NOTICE OF NSA DECISION

Case File: T2-2016-5199
Permit: NSA Site Review
Location: 1903 NE Marok Dr, Troutdale
Tax Lot 100, Section 30D, Township 1
North, Range 4 East, W.M.
Tax Account #R944300230
Applicant: Dan & Ligia Mates
Owner: Dan & Ligia Mates
Zoning: Gorge General Residential – 10
(GGR-10)
**Landscape
Setting:** Rural Residential

Summary: The applicant is proposing to construct a new 1,000 sq. ft. pole building and authorize a 168 sq. ft. tool shed and a 229 sq. ft. chicken coop and feed storage building through a National Scenic Area Site Review in the GGR-10 zone.

Decision: Approved with conditions.

Exhibit B.2

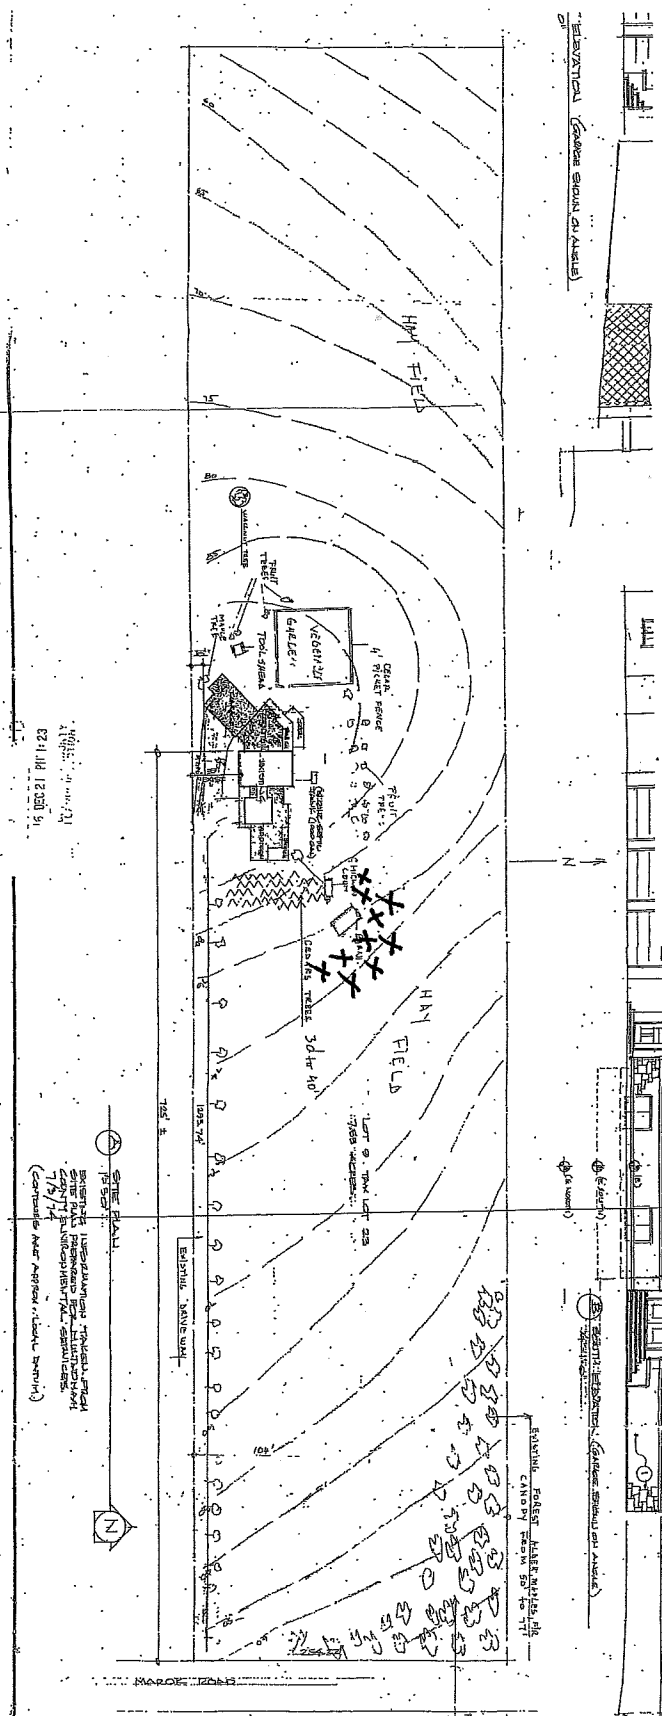
4. By April 1, 2018, the property owner shall install two (2) evergreen (Douglas fir and/or cedar) trees to the north of the chicken coop & food storage building as shown on Exhibit B.2. The two evergreen trees shall be at least five to six feet in height at time of planting. [MCC 38.7035(C)(3)]

5. By April 1, 2019, the property owners shall install eight (8) evergreen (Douglas fir and/or cedar) trees to the north and north east of the accessory building as shown on Exhibit B.2. The evergreen trees shall be at least five to six feet in height at time of planting. [MCC 38.7035(C)(3)]

6. The property owners shall maintain the new trees and the existing trees and vegetation as shown in Exhibit B.2 in living condition and shall replace any dead or damaged tree or required vegetation if they do not survive. Invasive species will need to be removed and controlled. The property owner is responsible for the retention and health of the trees to maintain the existing density on the property in perpetuity. Any and all vegetation required by T2-03-063 & T2-04-017 shall be maintained as conditioned by those decisions. [MCC 38.7035(B)(2) and (B)(8)]
